PIC18F2410/2510/4410/4510 Rev. B3 Silicon Errata

The PIC18F2410/2510/4410/4510 Rev. B3 parts you have received conform functionally to the Device Data Sheet (DS39636D), except for the anomalies described below. Any Data Sheet Clarification issues related to the PIC18F2410/2510/4410/4510 will be reported in a separate Data Sheet errata. Please check the Microchip web site for any existing issues.

The following silicon errata apply only to PIC18F2410/2510/4410/4510 devices with these Device/Revision IDs:

FIGURE 1: SCK PULSE VARIATION USING TIMER2/2

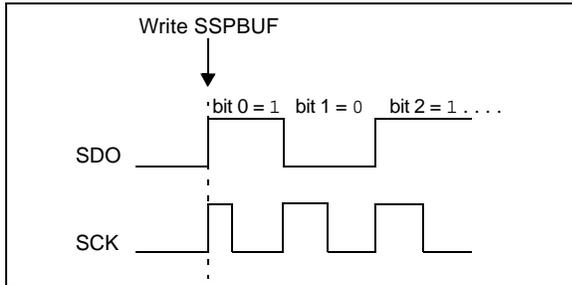
When the SPI is using Timer2/2 as the clock source, a shorter than expected SCK pulse may occur on the first bit of the transmitted/received data (Figure 1).

To avoid producing the short pulse, turn off Timer2 and clear the TMR2 register, load the SSPBUF with the data to transmit and then turn Timer2 back on. Refer to [Example 1](#) for sample code.
